UNITED STATES PATENT AND TRADEMARK OFFICE

APPLICATION NO.	FILING DATE	FIRST NAMED INVENTOR	ATTORNEY DOCKET NO.	CONFIRMATION NO.
10/775,250	02/11/2004	Masaaki Togashi	I18627	1178
25944	7590	02/16/2005	EXAMINER	
OLIFF & BERRIDGE, PLC P.O. BOX 19928 ALEXANDRIA, VA 22320			THOMAS, ERIC W	
			ART UNIT	PAPER NUMBER
			2831

Office Action Summary	Application No.	Applicant(s)
	10/775,250	TOGASHI ET AL.
	Examiner	Art Unit
	Eric W. Thomas	2831

DETAILED ACTION

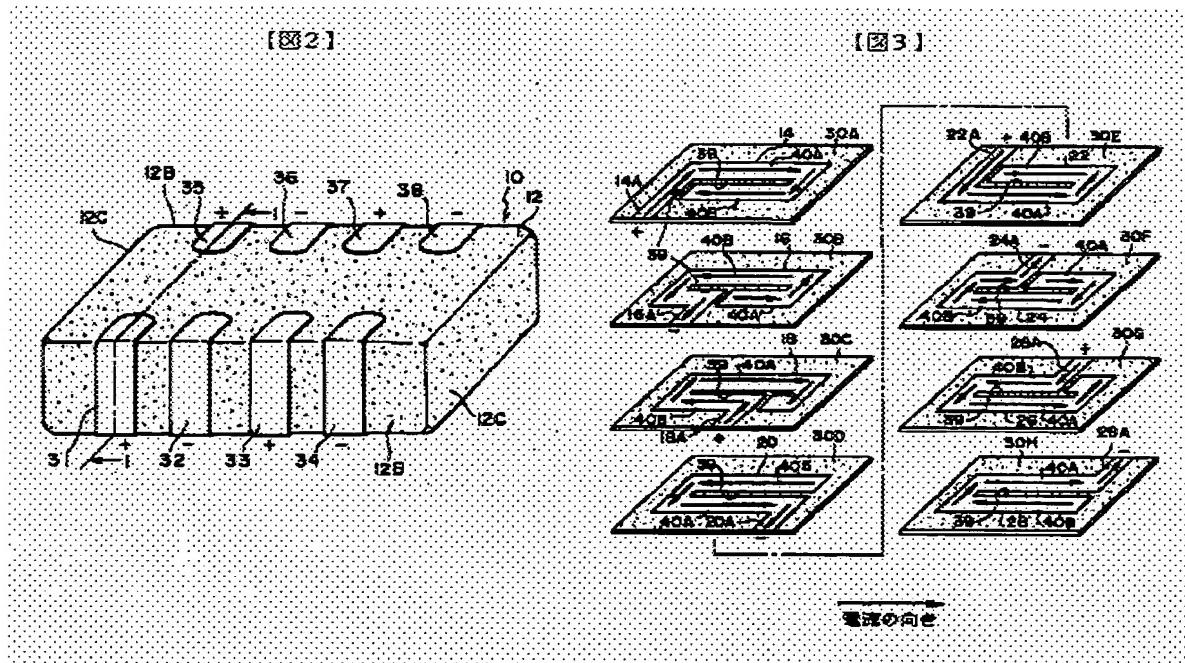
1. The indicated allowability of claim 1 (and all depending therefrom) is withdrawn in view of the newly discovered reference(s) to Togashi (JP 2002-164256). Rejections based on the newly cited reference(s) follow.

Regarding claim 3, Togashi discloses said lead parts are formed so as to be led out to only one surface of said dielectric body (see fig. 3 above).

Regarding claim 6, Togashi discloses said one surface of said dielectric body is formed with said first terminal electrode and second terminal electrode so as to extend along said stacking direction substantially in parallel at a predetermined interval (see fig. 2 & 3 above).

Regarding claim 8, Togashi discloses the first and second cut parts for forming the channel parts in the first and second internal conductor layers adjoining each other across the dielectric layer are formed at substantially the same positions between the internal conductor layers adjoining each other (see fig. 2, 3)

Regarding claim 9, Togashi discloses a starting point of the first cut part formed in the first internal conductor layer starts from near the first lead part of said first internal conductor layer, a starting point of the second cut part formed in the second internal conductor layer starts from near the second lead part of said second internal conductor layer, and these cut parts are formed at substantially the same positions between the internal conductor layers adjoining each other (see fig. 3).

Regarding claim 12, Togashi discloses said first and second cut parts are formed in the internal conductor layers to be alternately opposite in substantially perpendicular direction with respect to the longitudinal direction of said dielectric layer (as seen in the top portion of fig. 2 & 3).

Regarding claim 14, Togashi discloses the width of the uncut ends is "substantially" equal to the width of the channels (as seen in fig. 2-3).

Regarding claim 16, Togashi discloses one of the channel parts formed by the first cut part is extended to form the first lead part and one of the channel parts formed by the second cut part is extended to form the second lead part (see fig. 3).

Regarding claim 17, Togashi discloses the first lead part is led out to a first side surface of said dielectric body, and the second lead part is led out to another second side surface of said dielectric body facing said first side surface (fig. 2-3).

Regarding claim 22, Togashi discloses said first and second cut parts are formed running through a center part of each internal conductor layer along a longitudinal direction of each internal conductor layer and the uncut ends of the cut parts are arranged alternately opposite from each other via the dielectric layer (as seen in fig. 3 – (@30D and @30E)).

Regarding claim 25. Togashi discloses a width of said first and second lead parts is larger than a width of said channel parts (as illustrated in fig. 3).
